Subject: **Bid No. 8819-M7 – Sprinkler & Fire Alarm Modifications – Union Station / WRA**

ADDENDUM NO. 3

SPRINKLER AND FIRE ALARM
MODIFICATIONS PHASE 2
UNION STATION
WORCESTER, MA

FAD105

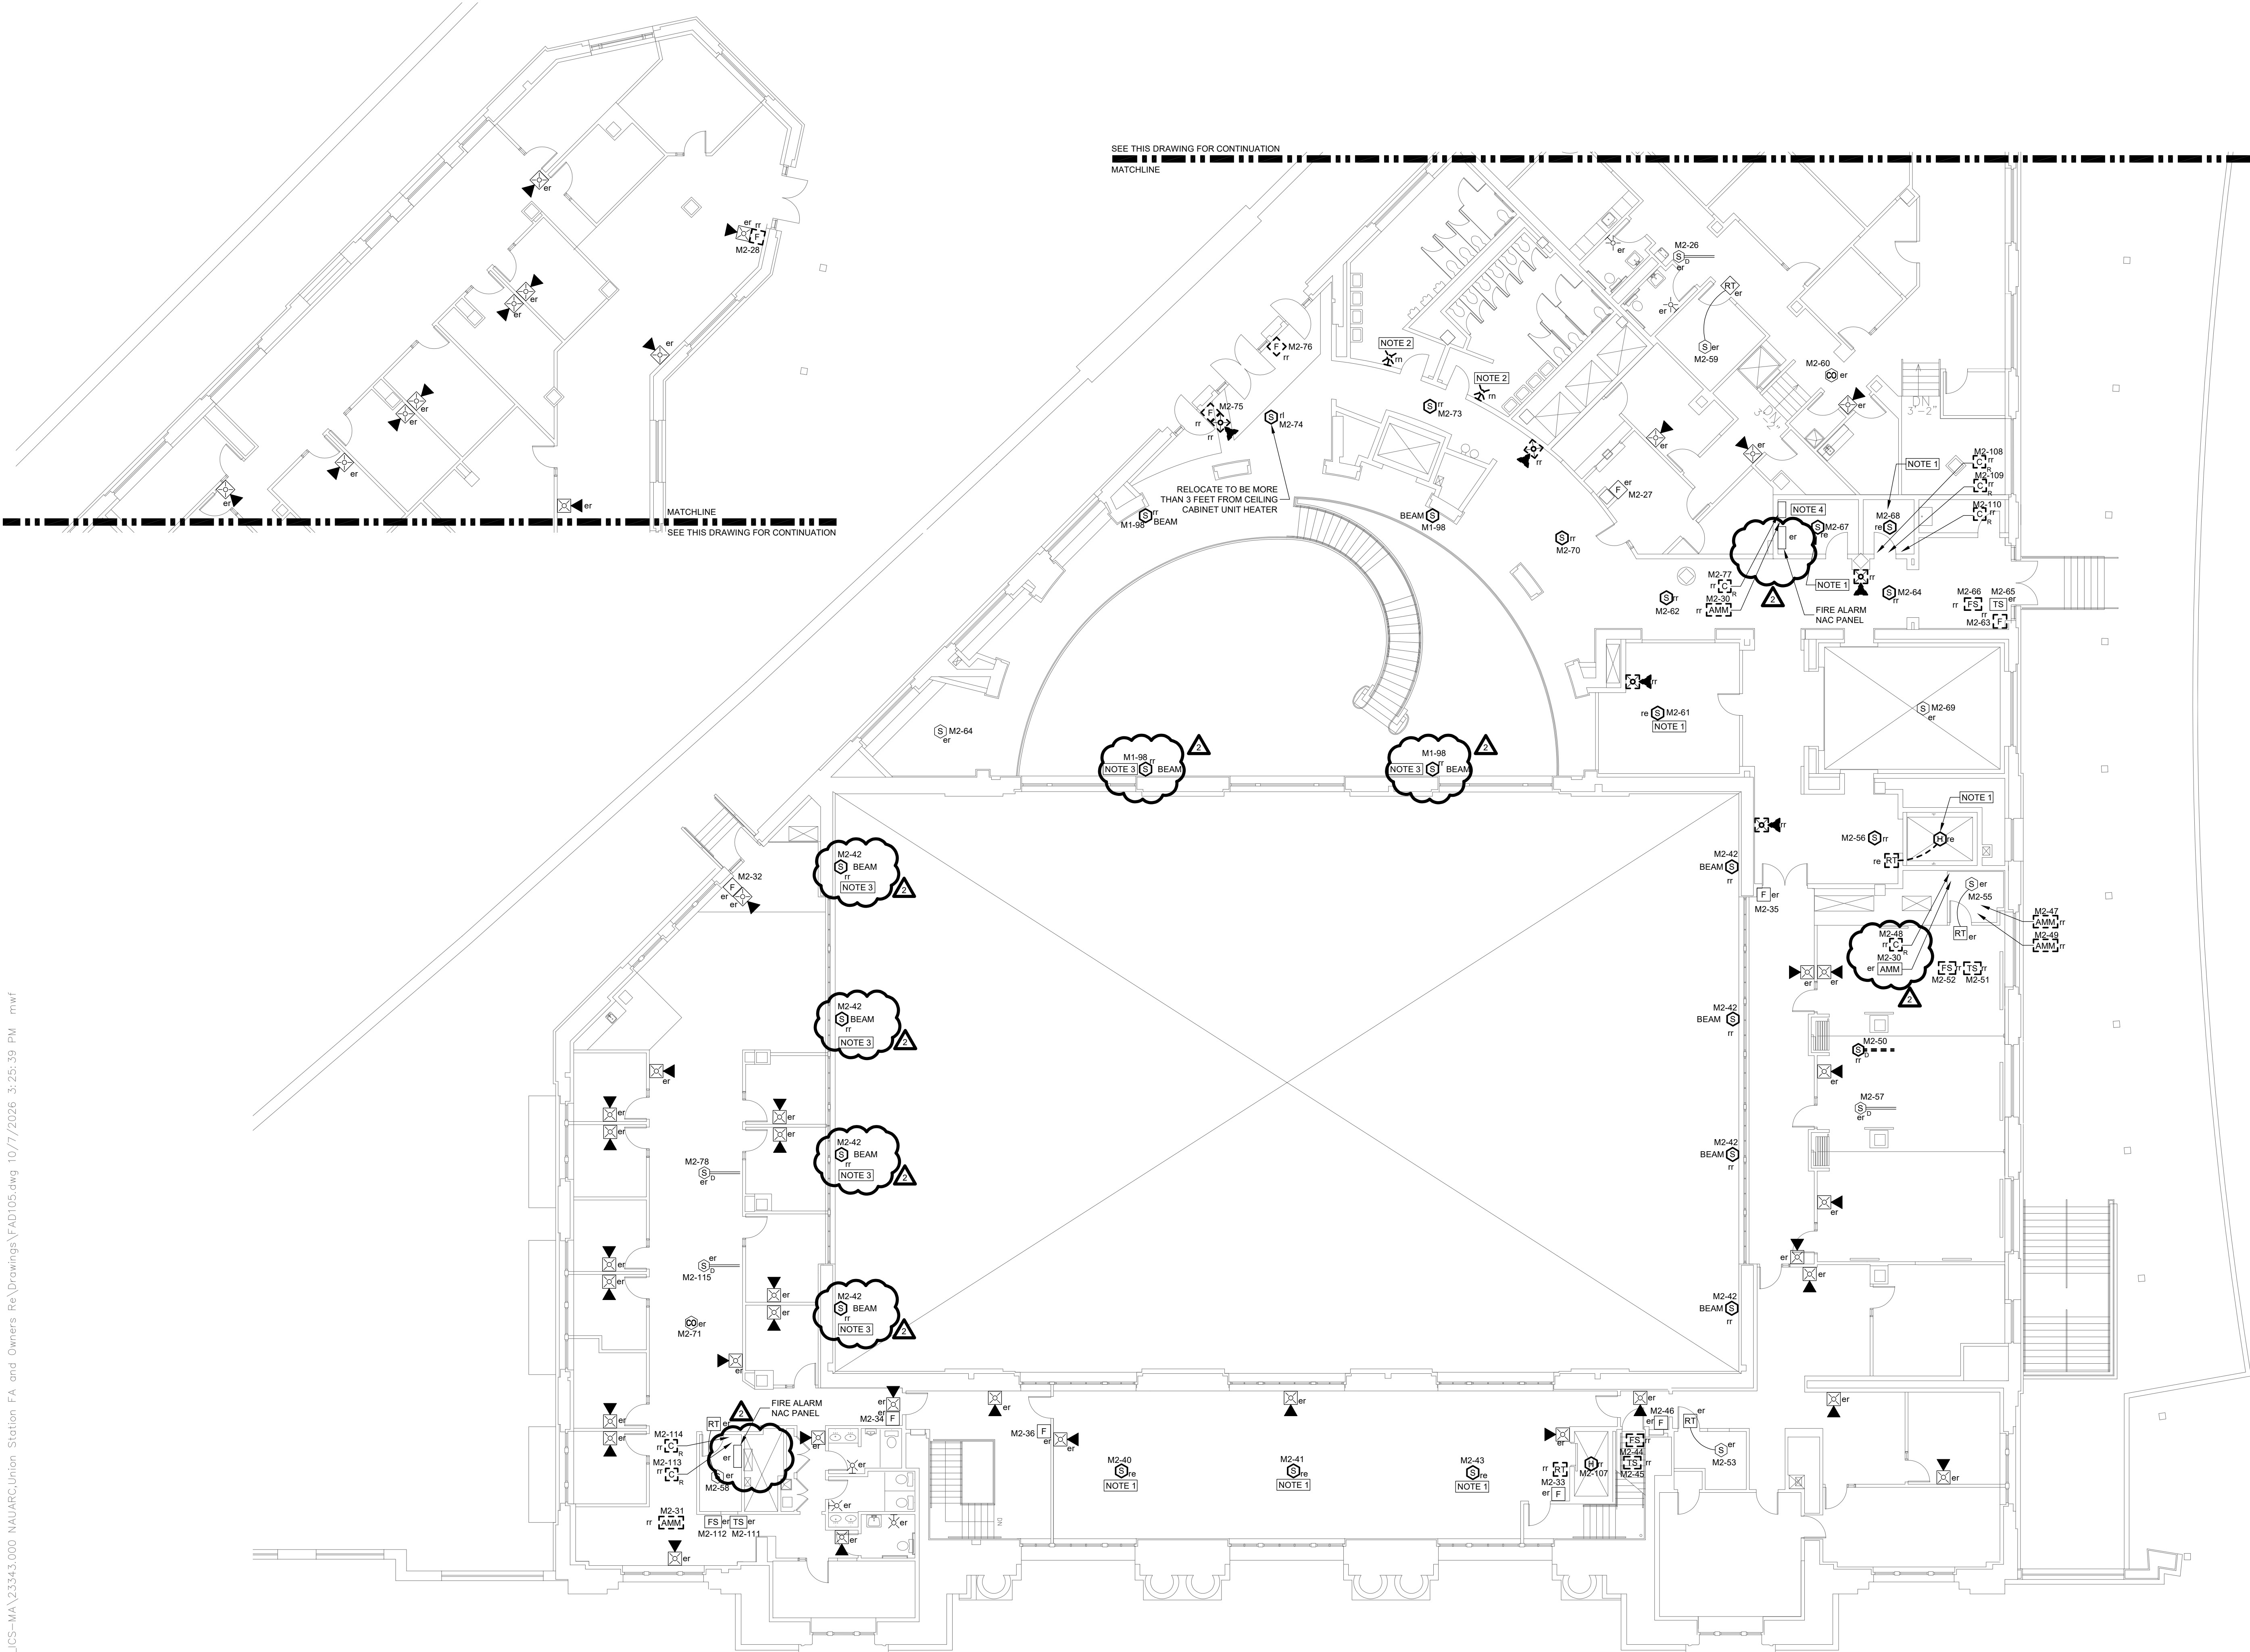
Drawing FAD105, Electrical Fire Alarm Second Floor Demolition Plan, Revise as follows:

- REVISE Note 3 to describe modifications to the beam detectors.
- REVISE symbols for Beam Detectors.
- REVISE Beam Detectors from “Existing to Remain” to “Remove and Replace”.
- REVISE two NAC panels from “Remove and Replace” to “Existing to Remain”.
- REVISE label for one addressable monitor module from “M2-50” to “M2-30”.

Q: There are several other discrepancies between FAD105 and FA105 regarding the counts and addresses on various "C" and "AMM" devices. M2-30, M2-77, M2-113. The modules that control the beam detectors are still not shown. Please clarify all.

Q: FAD105 (revised, Addendum 2) still has notation "rr" next to both FA NAC panels. FA105 has removed the "nr" notation next to these panels (one has added "er" notation). Please clarify scope.

A: Existing M2-30 being added to FAD105. The control relays for the two NAC panels are being removed. With the switch over to IDNet, the signal circuits go directly to internal signal relays in the NAC panels without the need for external control relays. The response to location of the beam detector addressable modules not being able to be located and documented remains unchanged.

A: Both NAC panels shall be existing to remain.

FA101

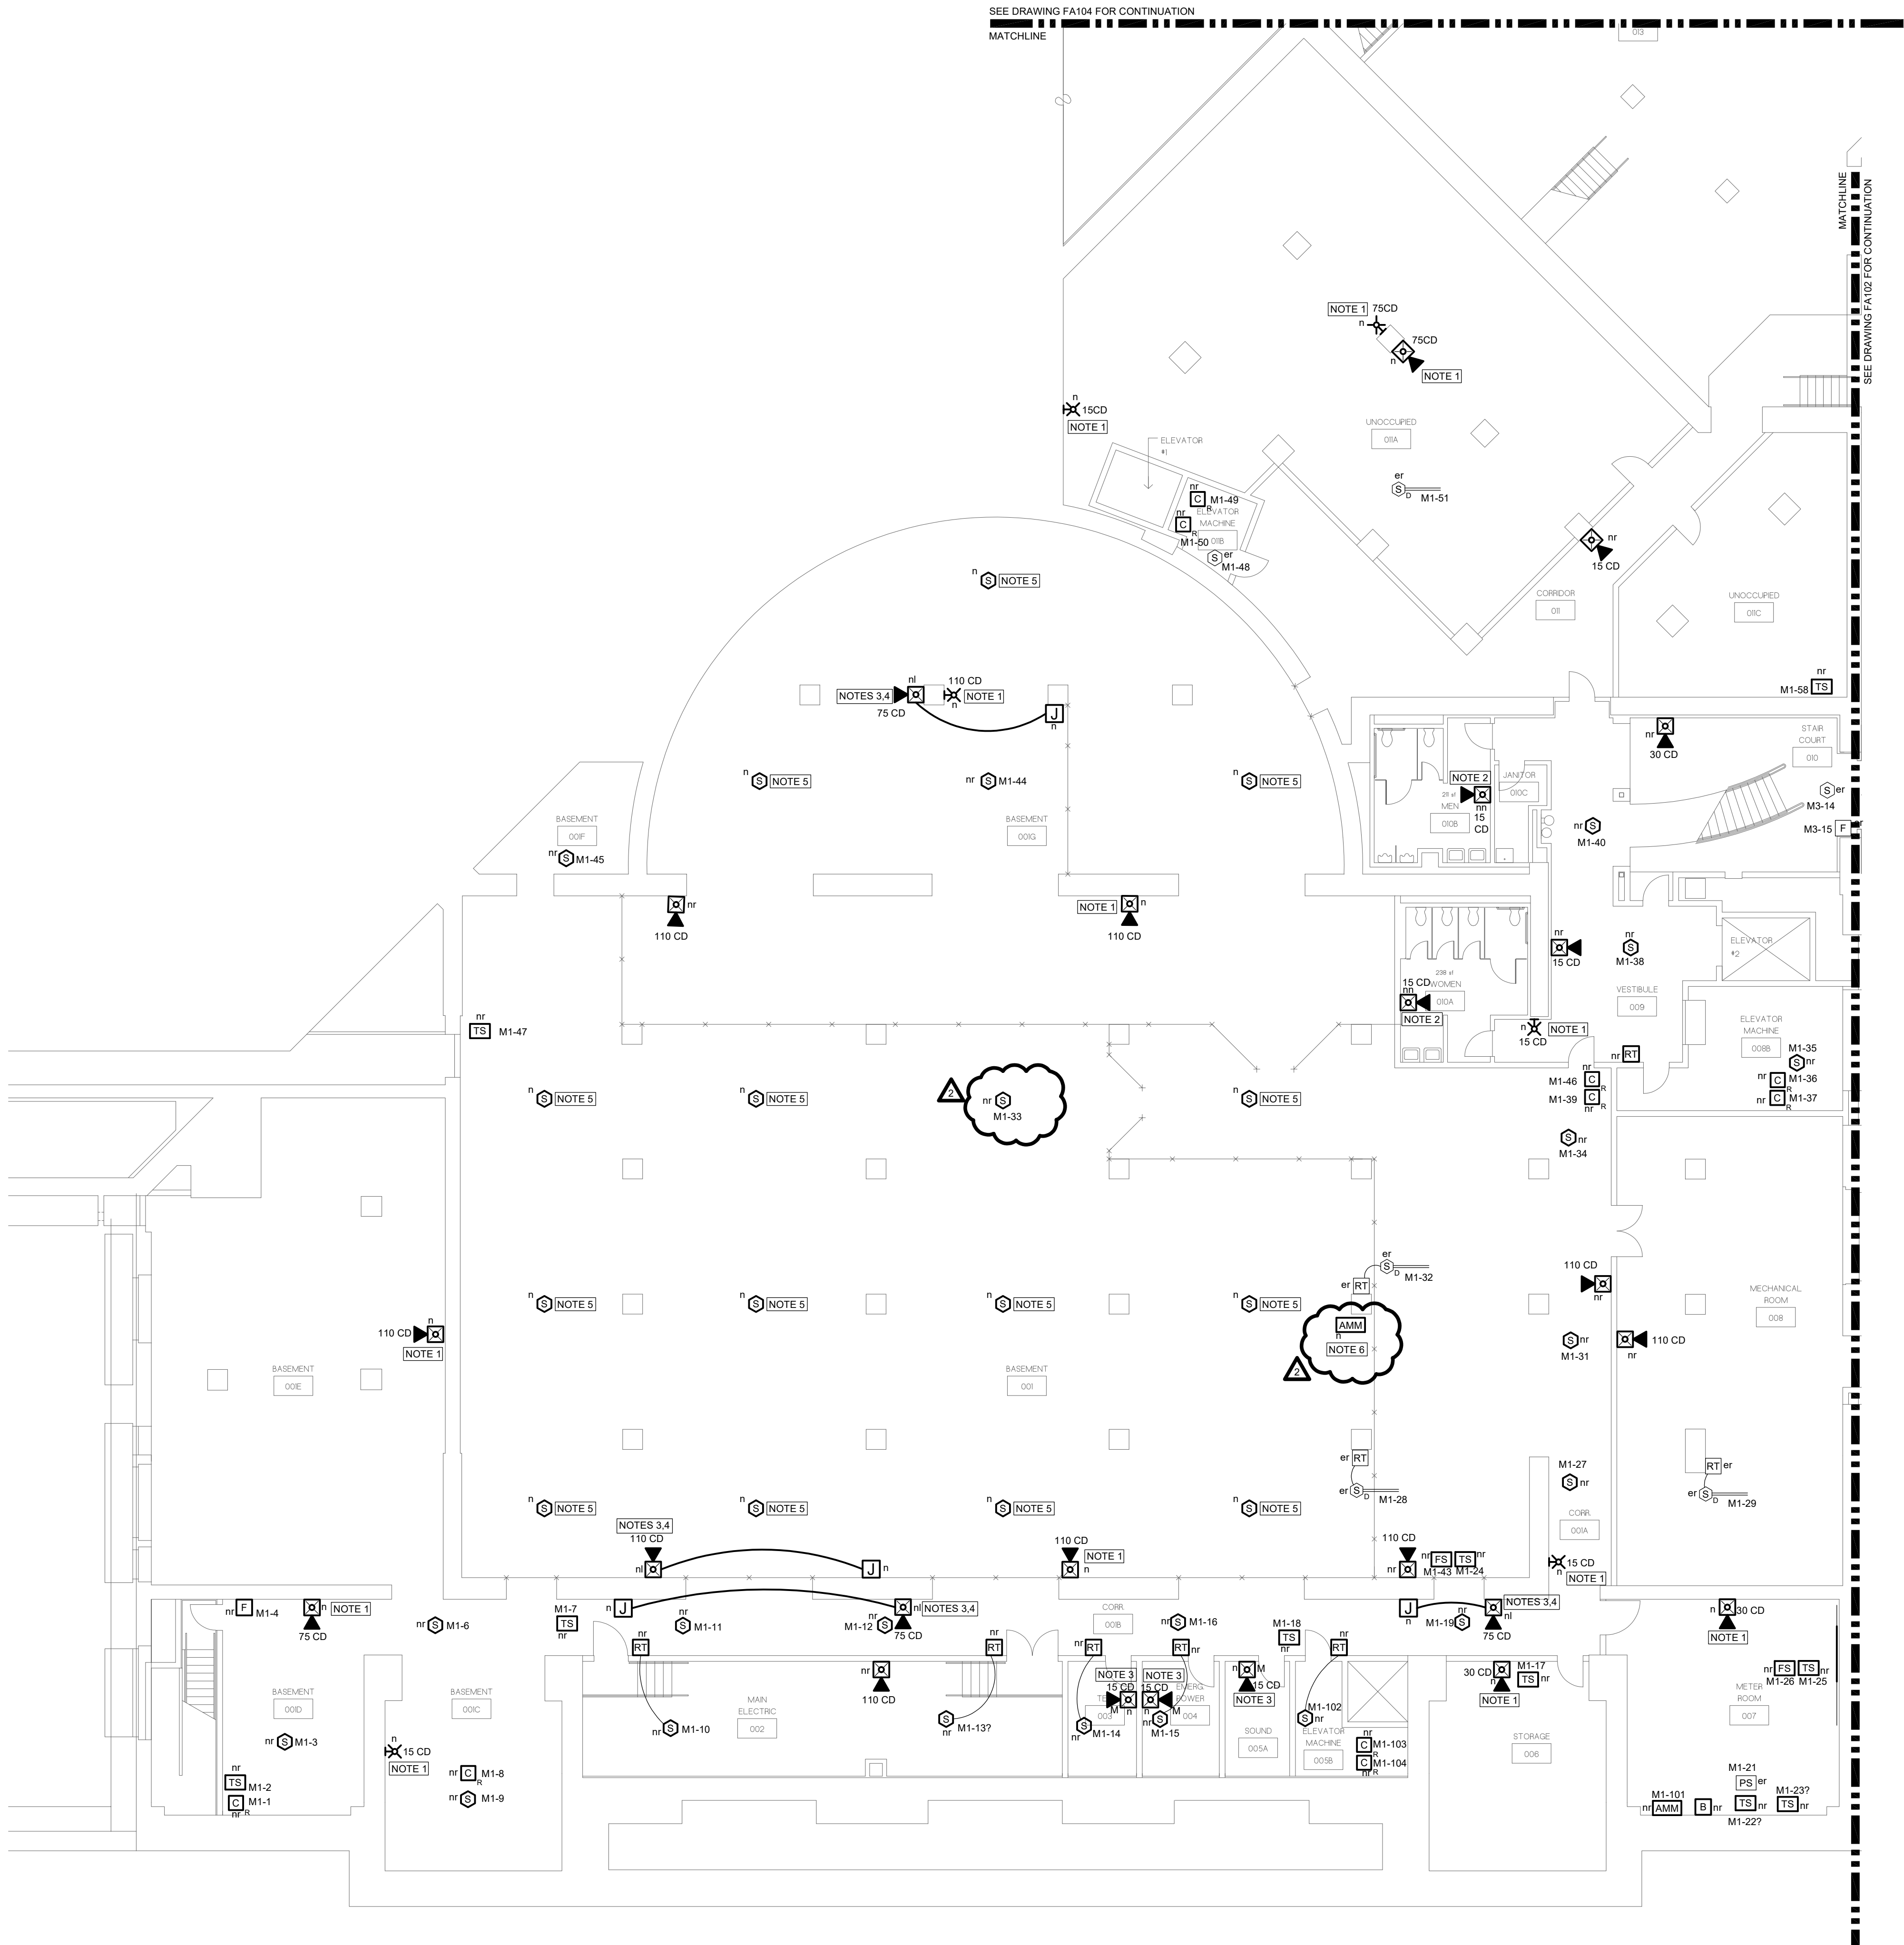
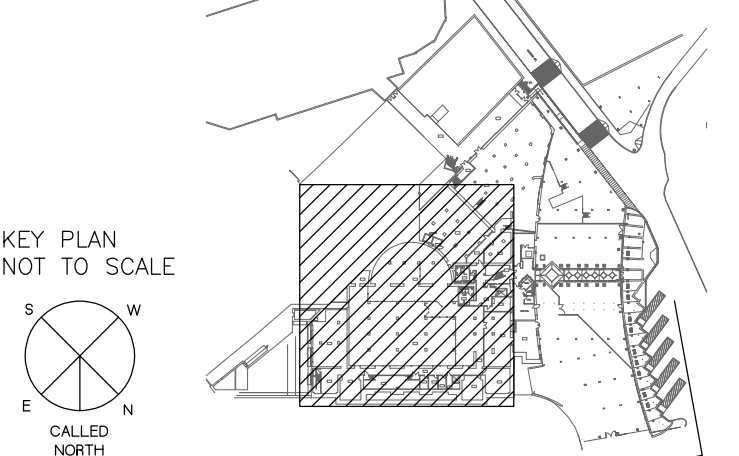
Drawing FA101, Electrical Fire Alarm Partial Basement New Work Plan, Revise as follows:

- DELETE reference to Keyed Note 1 at smoke detector M1-33.
- ADD addressable monitor module for leak detector controller monitoring and associated Keyed Note 6.
